## SERVICE BULLETIN

## SB017-494

Subject: Lancair IV  
Date: 7<sup>th</sup> April, 1994  
Ref: None  
Pages: 2  
Status: Advisory

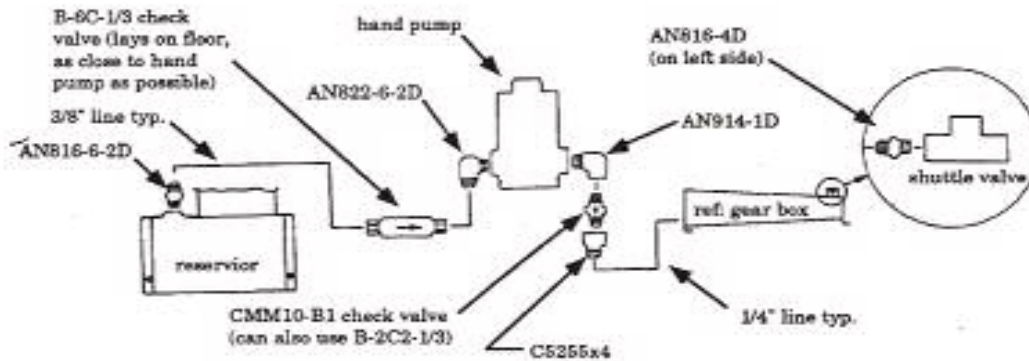
### 1. HAND PUMP CHECK VALVE LOCATIONS:

We are now recommending a modification to the hydraulic hand pump installation. The originally shipped instructions indicated installation of the hand pump check valve as being removed (on the reservoir for the supply side and at the shuttle valve for the pressure side).

While this works very well on our aircraft, failure analysis shows that a safer installation does exist and for this reason of increasing safety/reliability, we are recommending the installation change.

We will briefly highlight the installation changes in this writing in an effort to provide you the earliest possible notice and will follow with revised plans. The changes are quite easy to make and we strongly recommend that you opt for this revised installation.
